**Subject: GE Response to Results of NRC Acceptance Review for ESBWR
Design Certification Application – Item 2 (TAC # MC8168)**

DCD Acceptance Review Item 2:

TRACG Applicability for the Feedwater Line Break

Feedwater Line Model

Figure 3-1. Feedwater Line Model for FWL Break Analysis

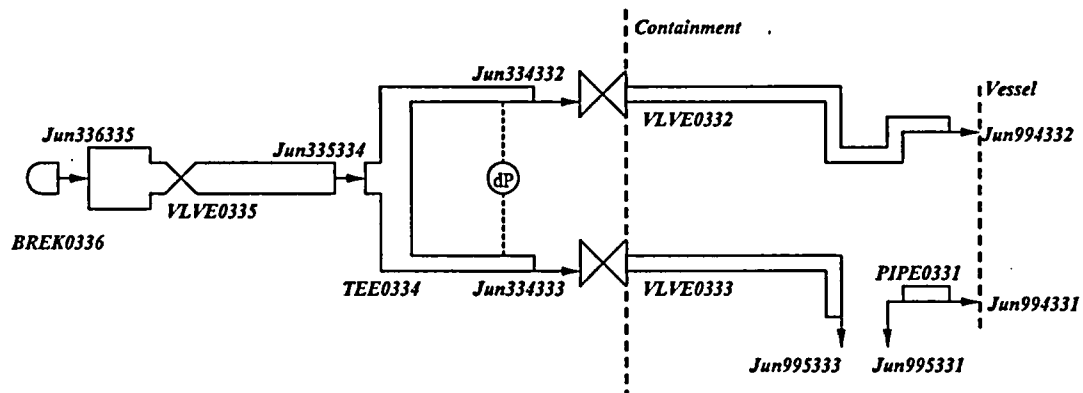
Provide design information to document that the largest possible feedwater line break location and area was considered. State the break area on both sides of the break. 10 CFR 50.46 requires that a spectrum of break sizes and locations be analyzed to demonstrate that the limiting break has been identified.

Figure 3-1 shows the schematic of the entire feedwater line model. The model encompasses the feedwater lines from the FW heaters to the RPV. Figure 3-2 depicts a single flow path that represents parallel trains of FW heaters and FW pumps in the Turbine Building. Elevations are conservatively assumed so that the inventory can be flashed into the containment through the postulated break location. Feedwater lines in the Steam Tunnel and in the containment are modeled with two loops: Intact Loop and Broken Loop, one for each 550 mm (22") main feedwater line in the steam tunnel and associated piping. Figure 3-3 shows a TEE component that represents the FW header in the Turbine Building and main feedwater lines in the Steam Tunnel. Two branches of TEE components end at the Isolation Valves near the containment boundary. Inside the containment, each 550 mm main feedwater line is physically connected to an arc-shaped header that also has three 300 mm (12") risers connected to the feedwater nozzles at the RPV. The flow area of the ring header is doubled to represent the branched flow and the three risers are combined in the TRACG model. Figure 3-4 shows the Intact Loop inside the containment. Figure 3-5 shows the Broken Loop inside the containment. A break is postulated at the connection of main feedwater line to the arc-shaped header in the broken loop. The break flow area is 0.1977 m^2 at each end. The break flow from the reactor is flashed through one of these areas and the break flow from FW heater, pumps and the Intact Loop is flashed through the other area. The break flow from the reactor is limited by the feedwater spargers inside the RPV. The total flow area of spargers associated with three feedwater risers is 0.08387 m^2 . The location of modeled spargers is indicated in Figure 3-5. Figure 3-6 shows the calculation for the assumed FW Line break area.
